Access Compliance Report Public Rights-of-Way (Curb Ramps)

Intersection ID: 42552 Main Street: ESTHER_LN **Cross Street: LUNDY_LN** Location:

Severity Score: 13.75 **Overall Compliance: No ADA ID: 051C05AC71FD** Ramp Type: Perp Initial Pass/Fail: Fail

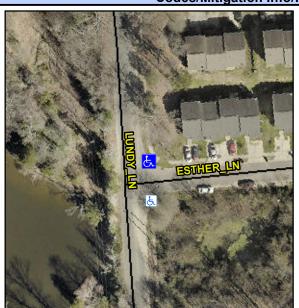
1 Ossible Solution	
Possible Solutions:	<u>c</u>
Remove & Replace Entire Ramp.	N
·	Υ
	N
	N
	N
	N
Surveyor Notes:	N
N/A	N
	N
	N
	N
PROW/ADA:	N
Not Found, R304.2.2, R304.5.3	N
,	N
	N
	N
